Email: Desert Harvest Solar Project EIS

NOTICE OF AVAILABILITY OF A DRAFT ENVIRONMENTAL IMPACT STATEMENT/ DRAFT CALIFORNIA DESERT CONSERVATION AREA PLAN AMENDMENT FOR THE DESERT HARVEST SOLAR PROJECT, (SCH # 2011094004), RIVERSIDE COUNTY

Notice of Availability of the Draft enXco Desert Harvest Solar Farm Project
Environmental Impact Statement, Riverside County, CA and the
Draft California Desert Conservation Area Plan Amendment (CACA 49491)

The Metropolitan Water District of Southern California's Detailed Comments on the April 2012 Desert Harvest Solar Project Draft EIS and Draft CDCA Plan Amendment

42. On page 4.30-51, revise the third sentence of the third full paragraph from:

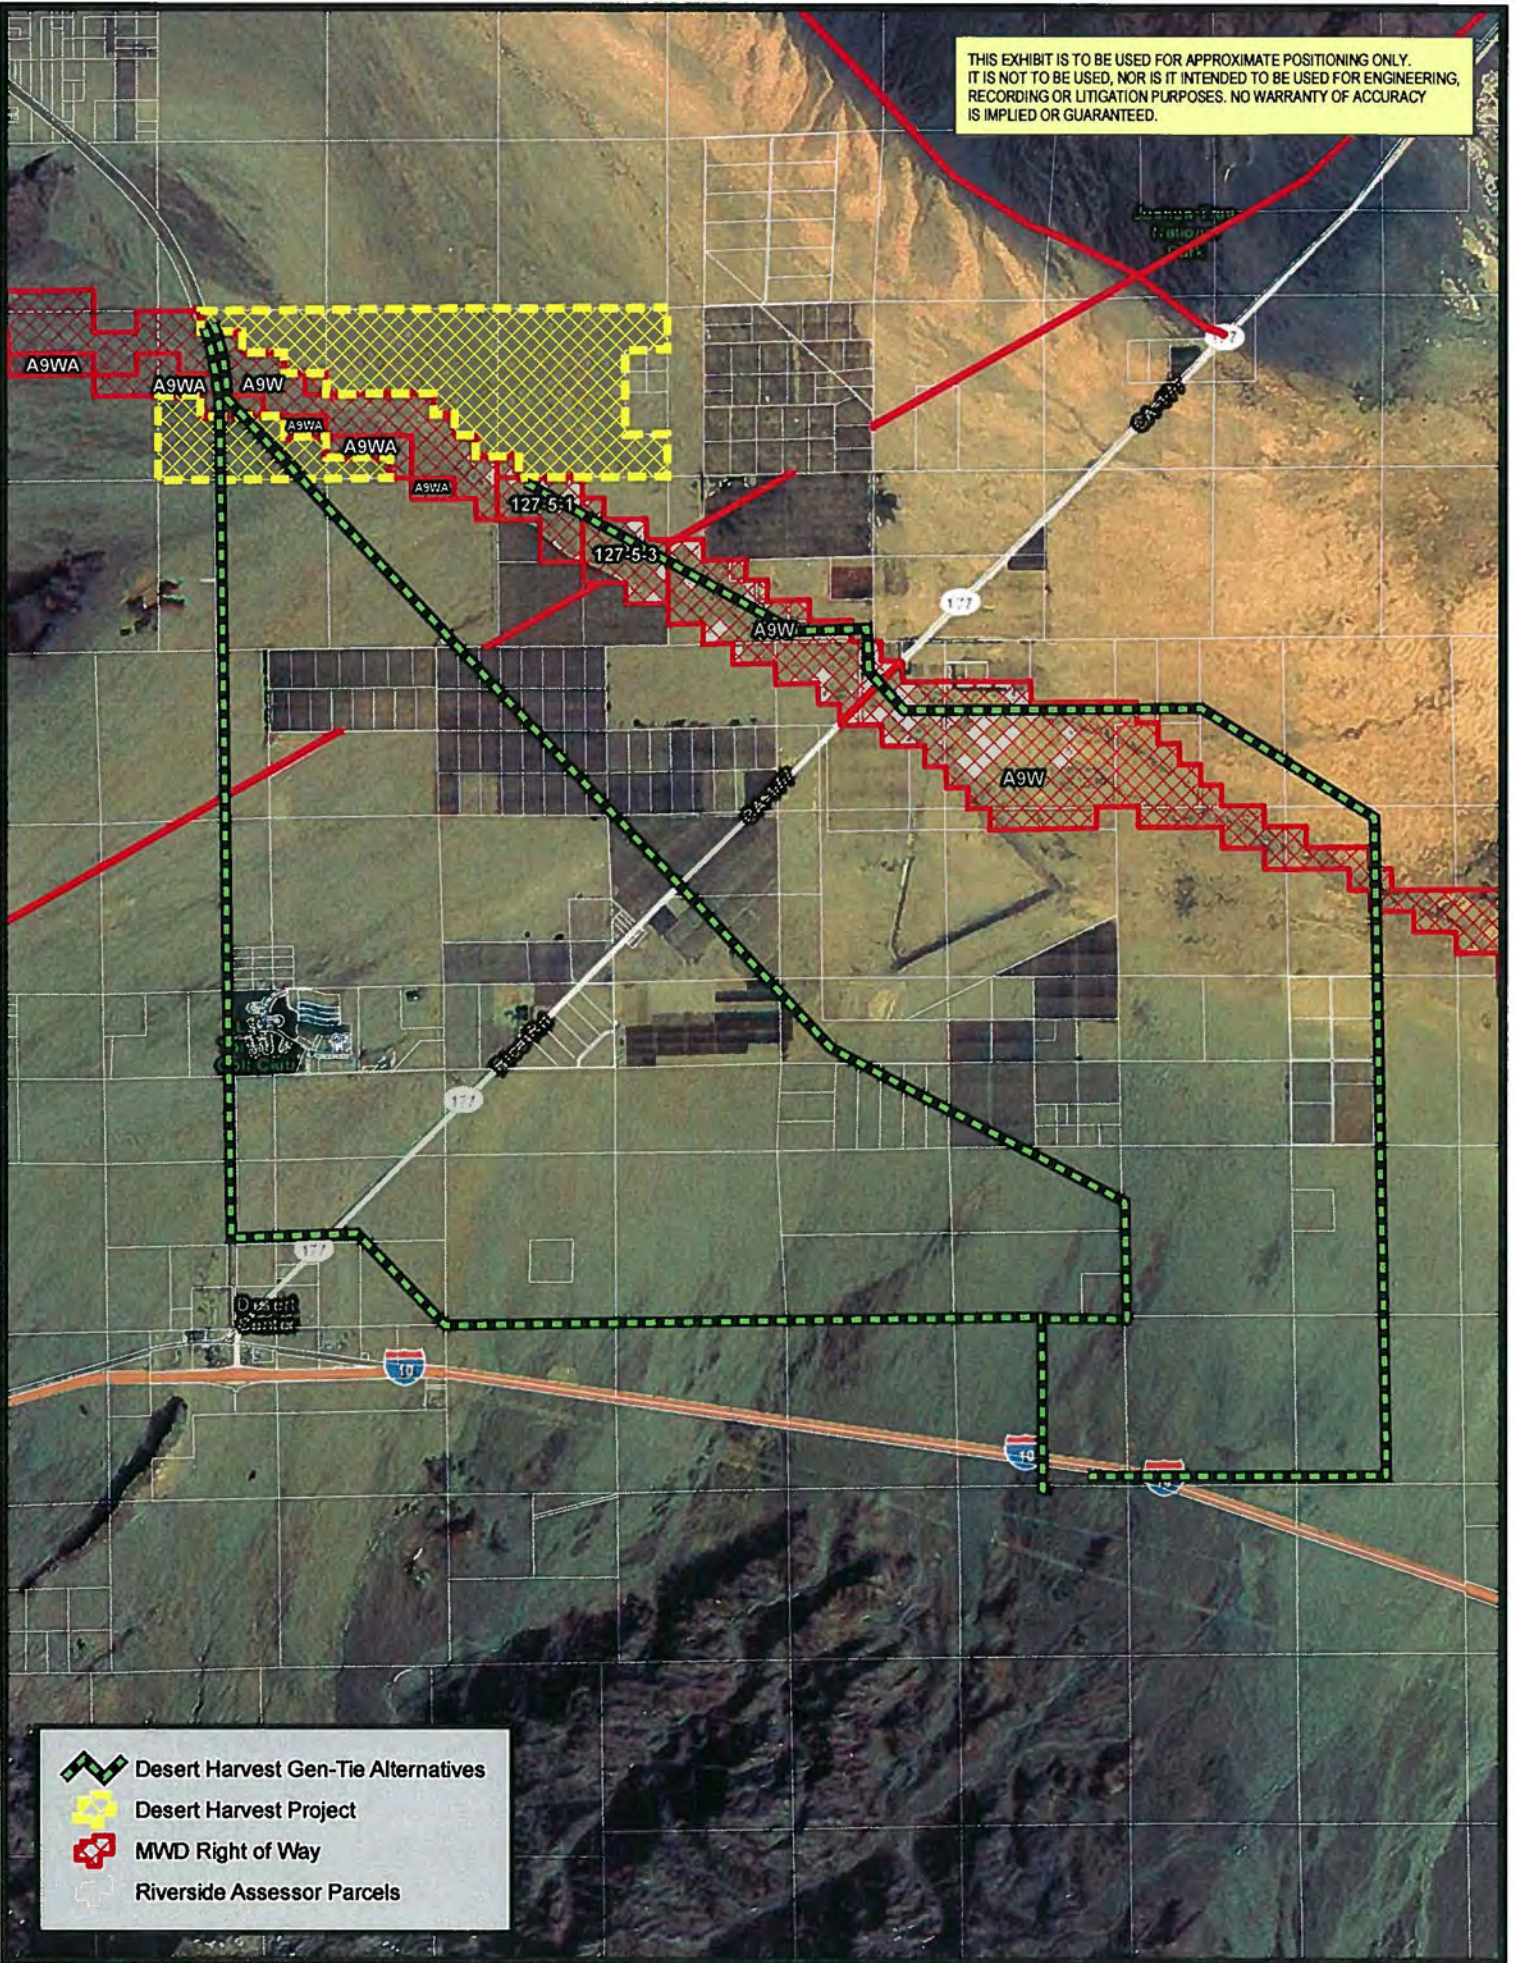
“Alternative B would require a water supply of 6.25 afy, is accounted for in the water availability projections included in the WSA provided as Appendix E. ”

to:
